Recommendations to Refine the Oct 27 VGI Straw Proposal by CPUC-CARB staff

November 29, 2017

Recommendation: Clarify End-to-End Architecture Definitions Including the EVSE Role

Protocol layer mapping to EVSE interfaces with clarifications

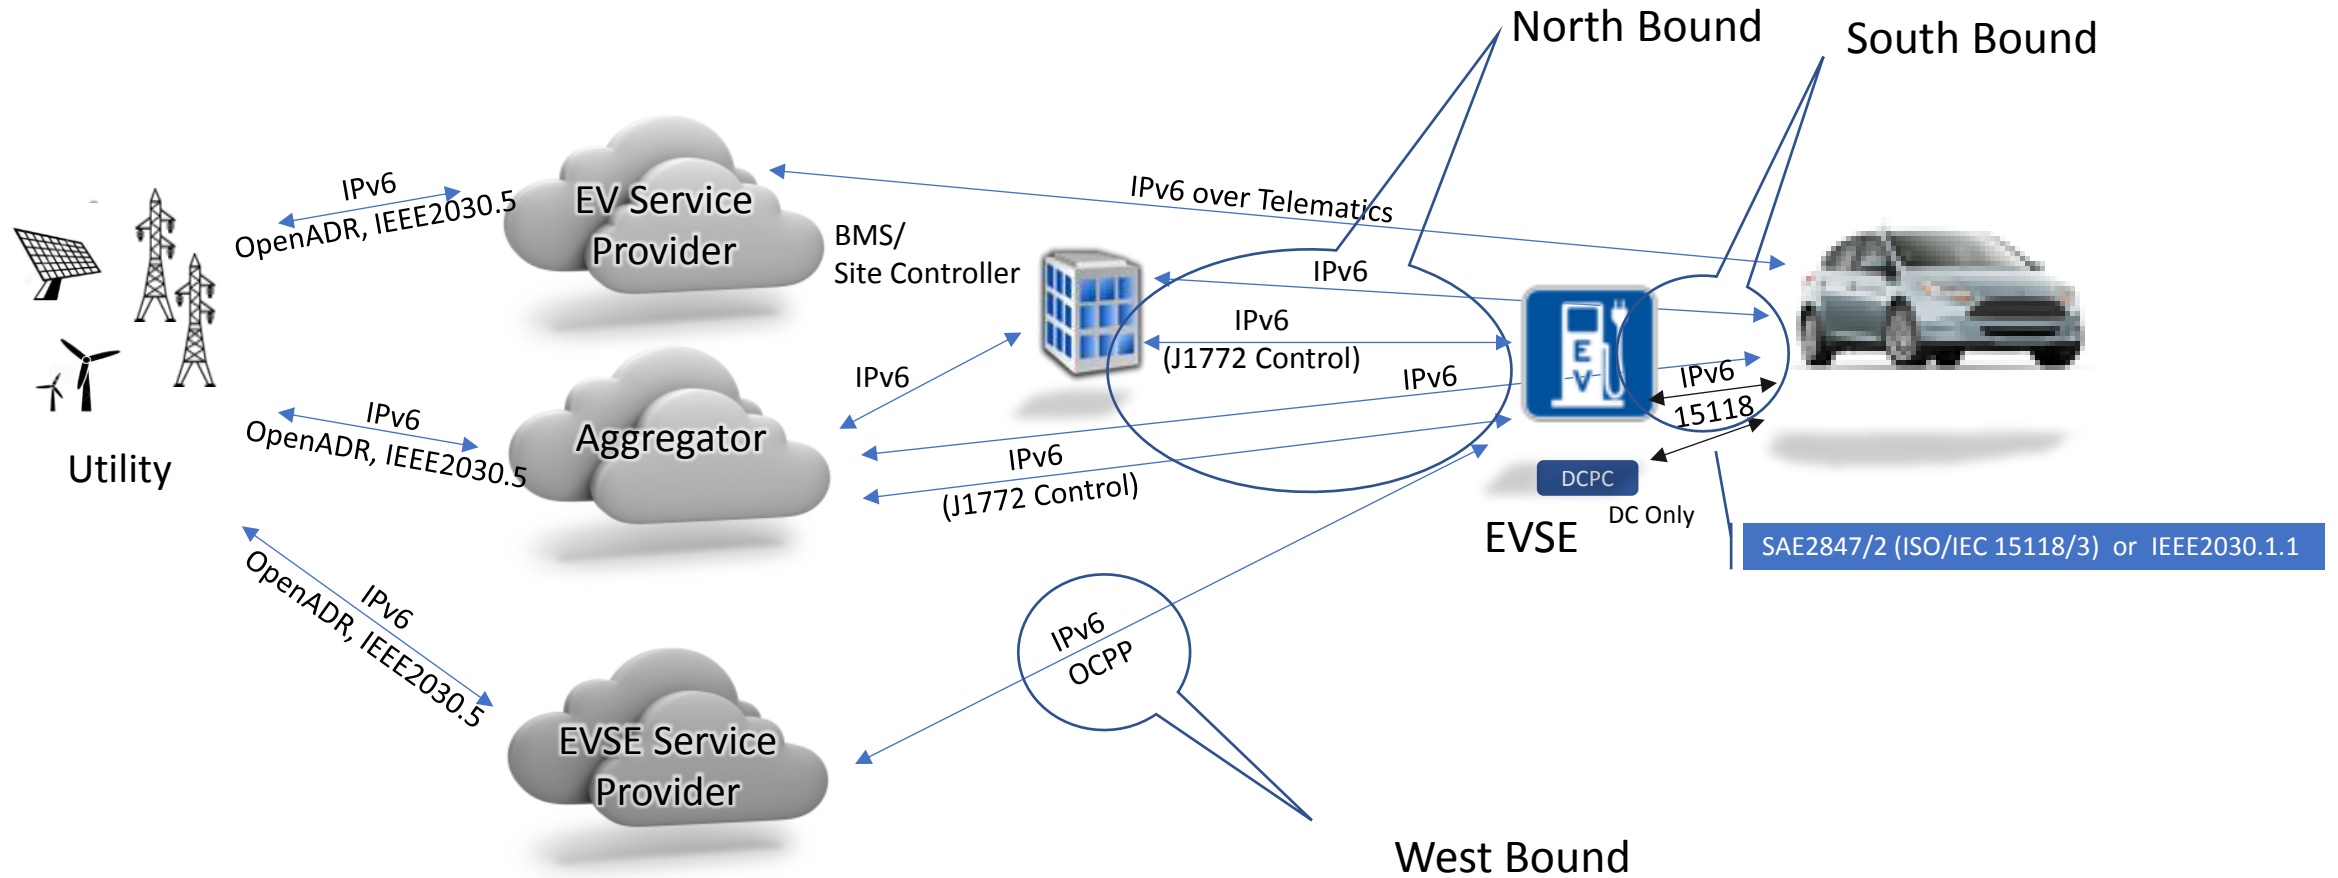
Note: Telematics is not northbound, southbound or westbound because it by-passes the EVSE

Red Font indicates **additions/clarifications to the Oct 27 CPUC-CARB staff proposal**

Recommend additional clarifications to include in final report

- Recommend explicitly continuing to allow the ability to load control EVs via J1772 PWM
- Recommend explicitly allowing alternative architectures for site hosts that are managing multiple EVSEs
 - E.g., BMS or site controller in order to provide flexibility to site hosts to lower costs
- Recommend defining “multi-use” to mean only AC, level 2, public-access locations including workplaces or common areas in MUDs with unassigned parking
 - Exclude non-publicly accessible locations including home, fleet and workplace locations
